ADDENDUM No. 01

Coaldale Government Building

Project No.: 9030

Project:	Coaldale Protective Services Building	File No.	841-004
Client:	Stephens Kozak – ACI Architects and Planners	Addendum No.	S1
Copy:		Date:	February 12, 2019

REVISED TYPICAL EXTERIOR DOOR STOOP

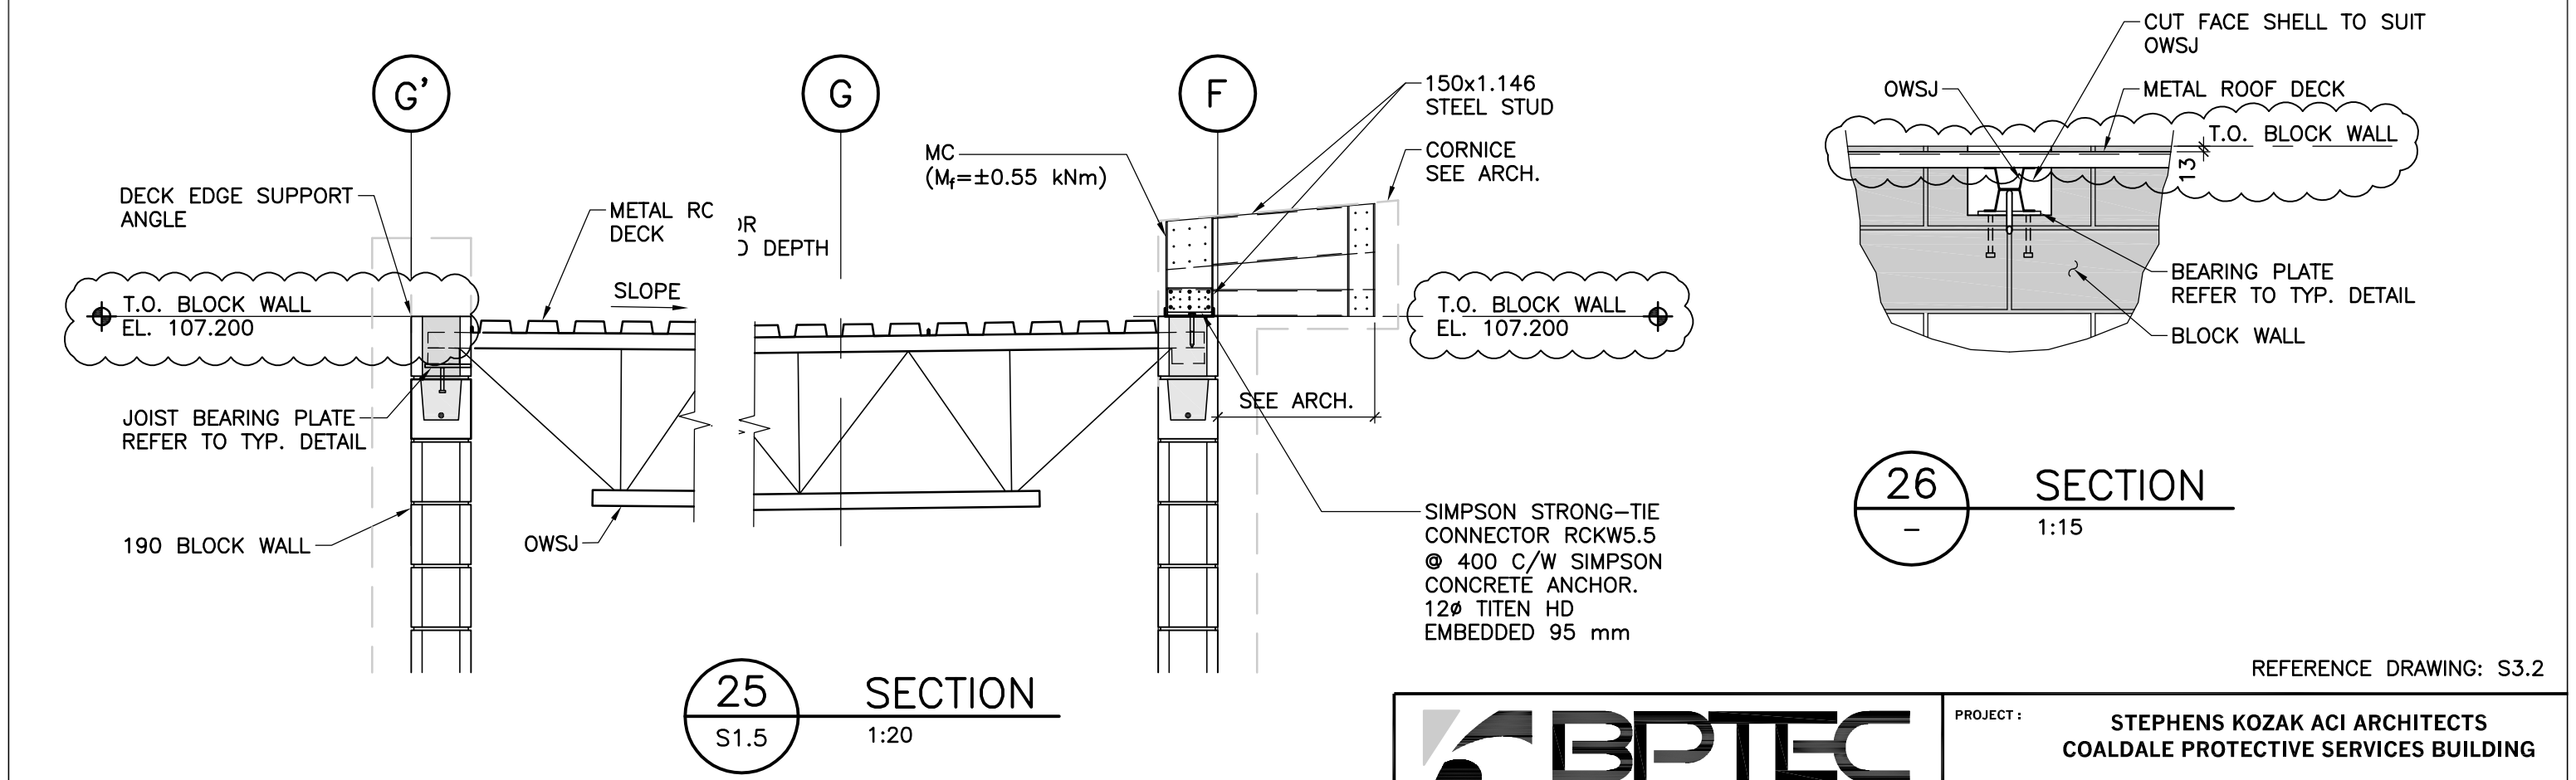
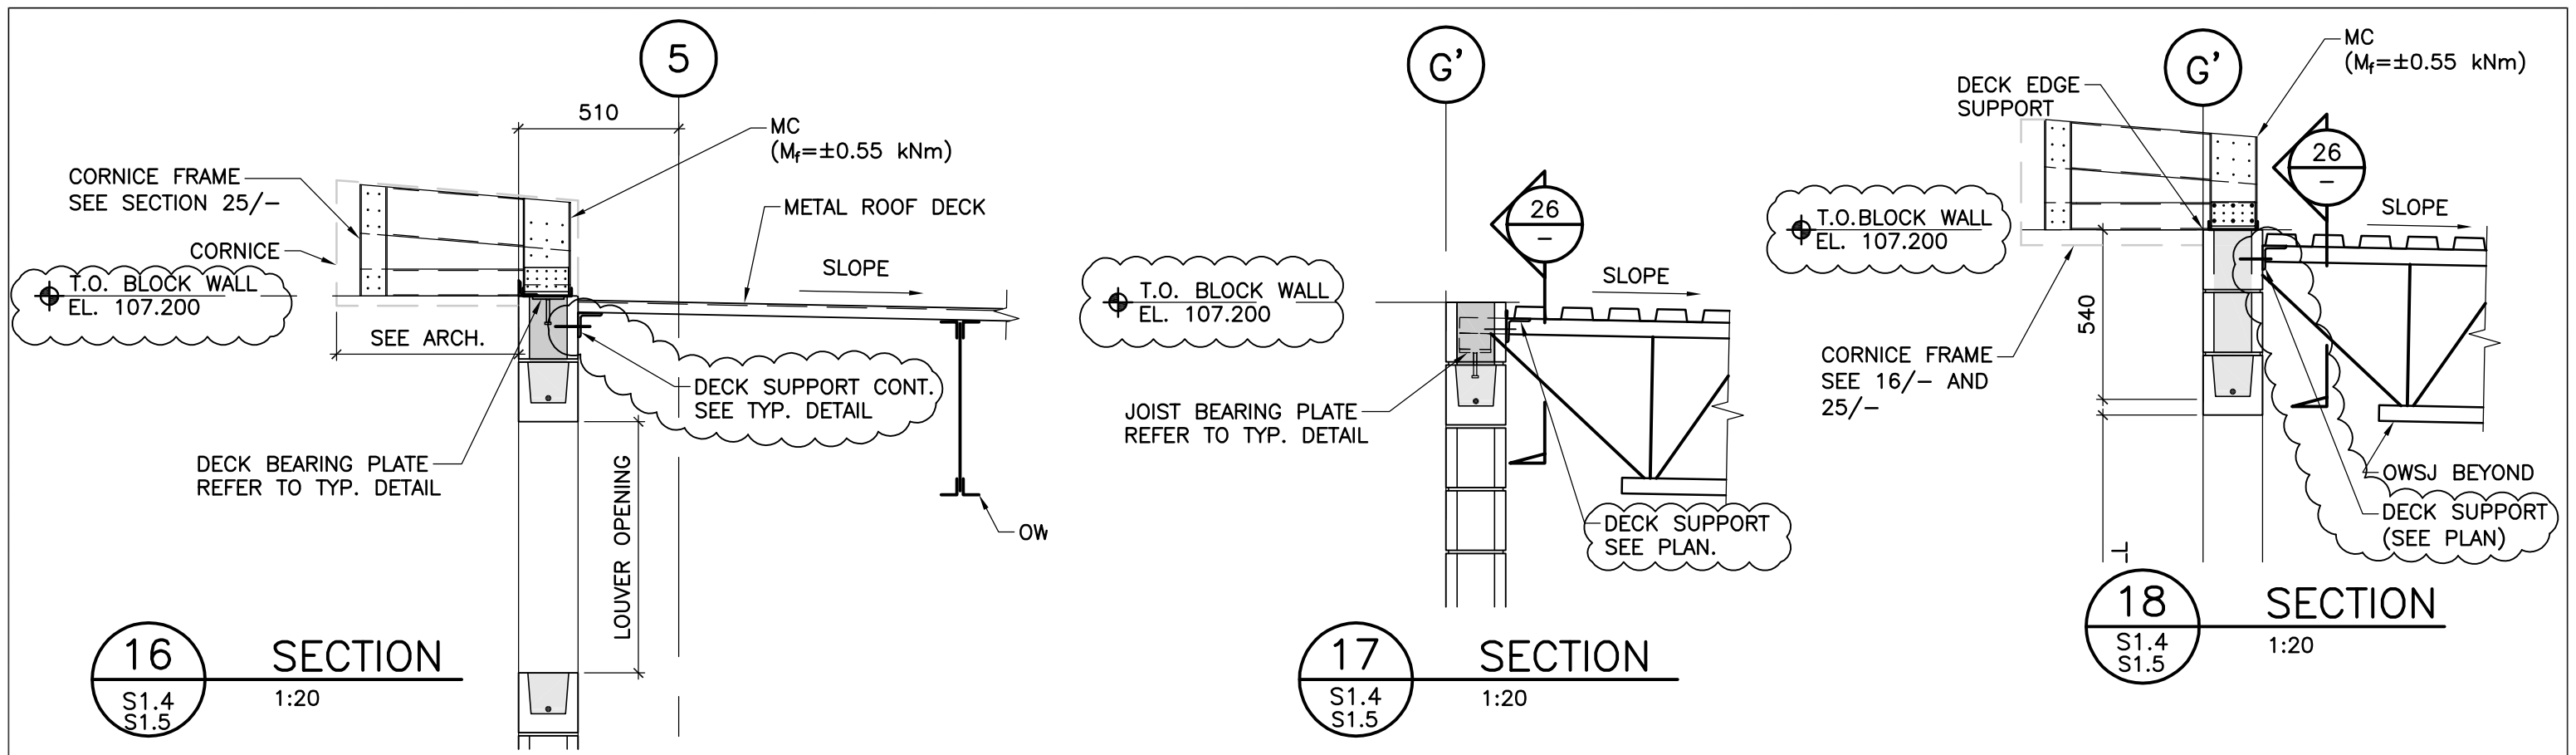
.2.1 On Typical Exterior Door Stoop, add '15Mx300 LG Dowel @ 400 Into Sidewalks Where Applicable' as per SSK-017.

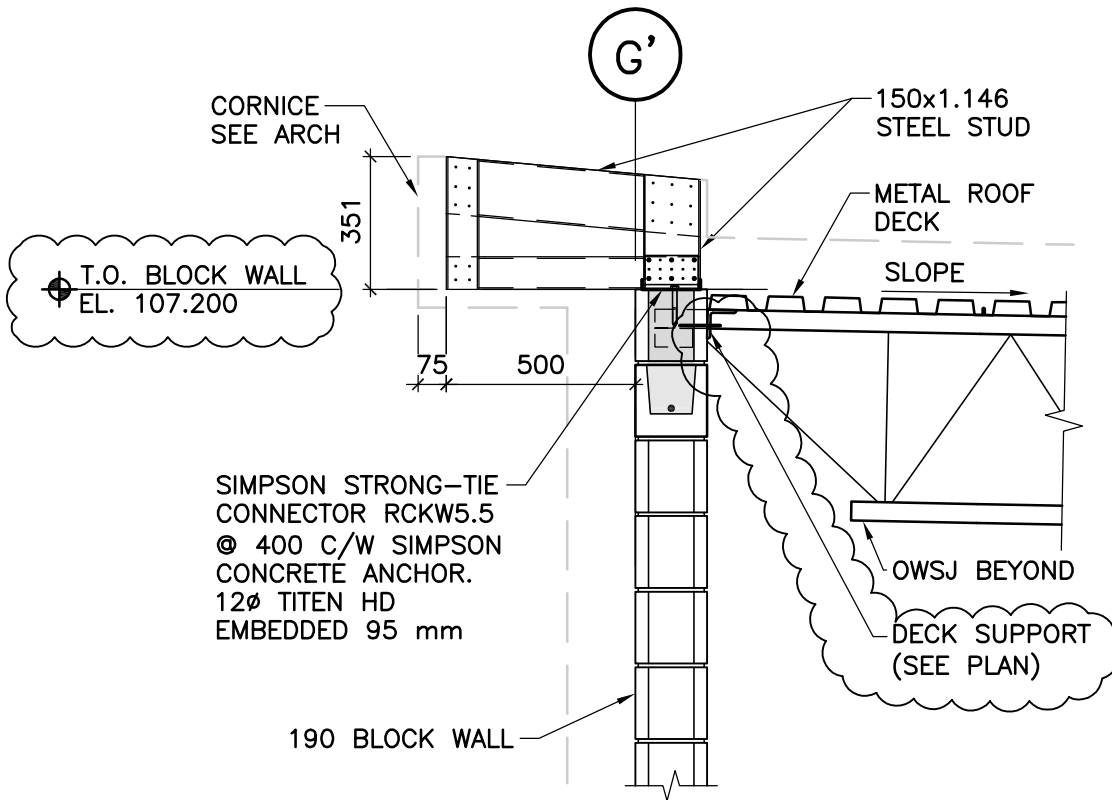
.9.2 Revise sections 16, 17, 18, 25, and 26 as clouded on SSK-018.

<p>Suite 200, 4220-98 Street NW Edmonton, AB T6E 6A1</p> <p>(780) 436-5376 www.bptec.ca</p>	PROJECT: STEPHENS KOZAK ACI ARCHITECTS COALDALE PROTECTIVE SERVICES BUILDING		
	DRG. TITLE: REVISED SECTION 5 AND 6		
DRAWN: NM	DATE: FEB. 12, 2019	FILE No.: 841-004	SKETCH No.: SSK-020

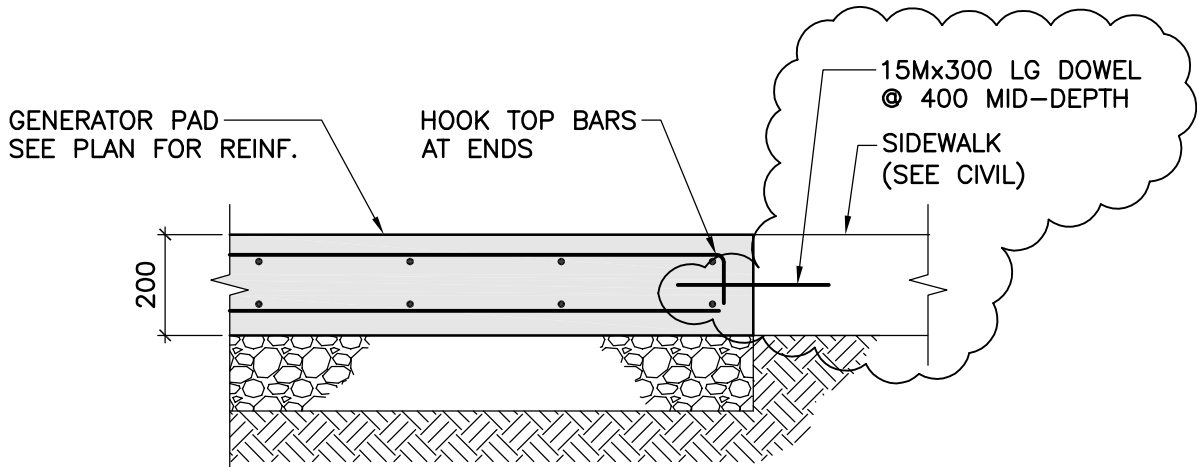
- .8 Drawing S3.1 Roof Sections Sheet 1**
- .8.1 On section 5, add axial forces of 75 kN in horizontal, vertical and diagonal braces (HSS 102x102x6.4).
Revise note 'Bent PL 6 Cont.' to read 'Bent PL 6 Cont. Weld to C310x31' .
Revise canopy steel dimension 375 to read 440 as clouded on SSK-020.
Delete U/S Girt elevation.

- .8.2 On section 6, add axial forces of 75 kN in horizontal, vertical and diagonal braces (HSS 102x102x6.4).
Revise note 'Bent PL 6 Cont.' to read 'Bent PL 6 Cont. Weld to C310x31' .
Delete deck inside canopy.
Revise canopy steel dimension 375 to read 440 as clouded on SSK-020.
Delete 'U/S Girt' elevation.

PROJECT :				STEPHENS KOZAK ACI ARCHITECTS COALDALE PROTECTIVE SERVICES BUILDING			
DRG. TITLE :				REVISION TO SECTION 13 ON S3.1			
DRAWN :		DATE :		FILE No. :		SKETCH No. :	
NM		FEB. 12, 2019		841-004		SSK-022

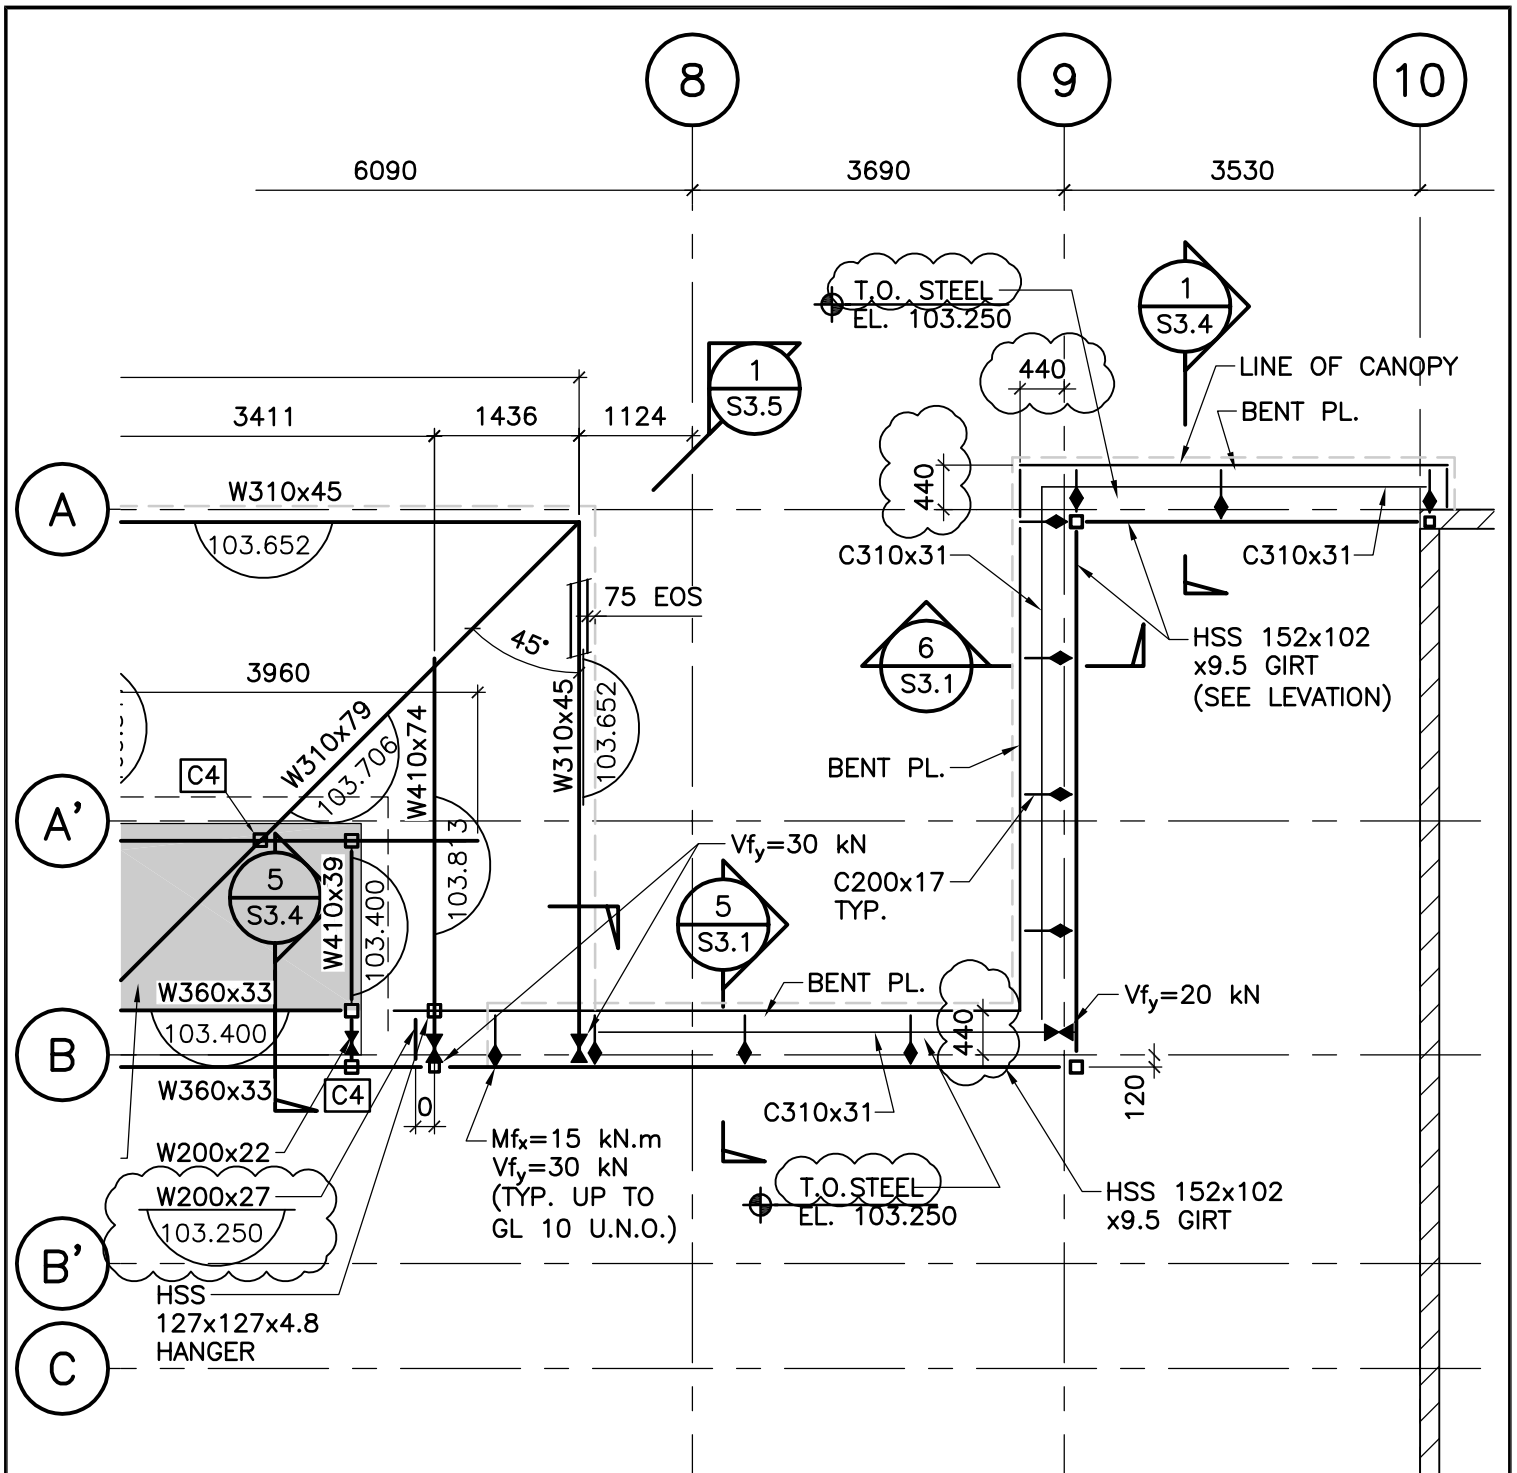
.8.9 Revise section 13 as per SSK-022.

DRG. TITLE : REVISED NORTH CANOPY DIMENSION

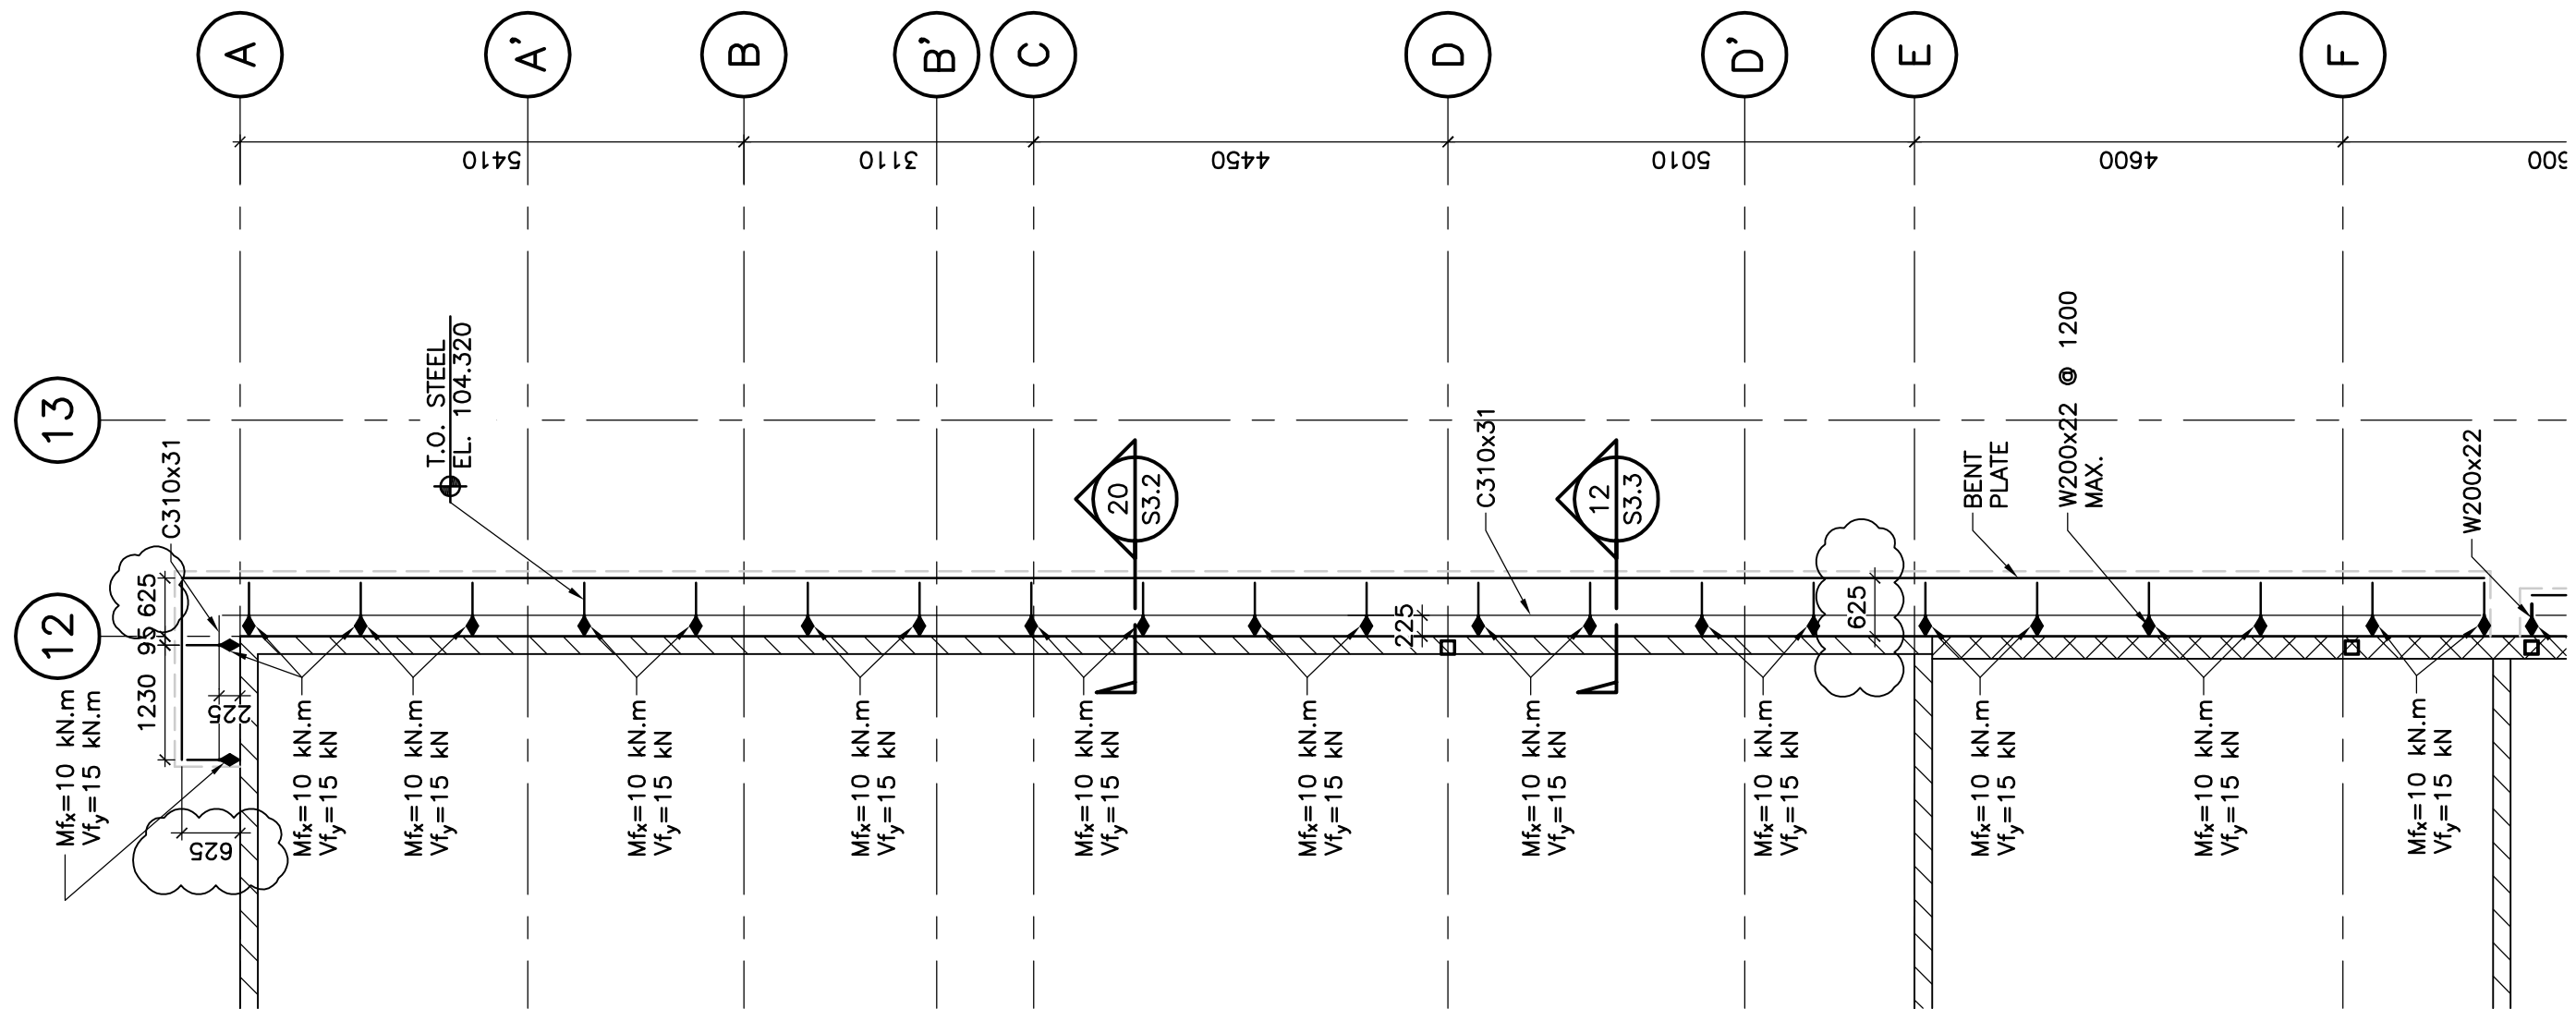
.6.4 On North Canopy Framing Plan, revise dimension '375' to read '440' as clouded on SSK-023.

Revise 'U/S Deck' to read 'T.O. Steel' as clouded on SSK-023.

.6.8 Add beam elevation bubble '103.250' under W200x27 near gridline B and west of gridline 8 as clouded on SSK-023.
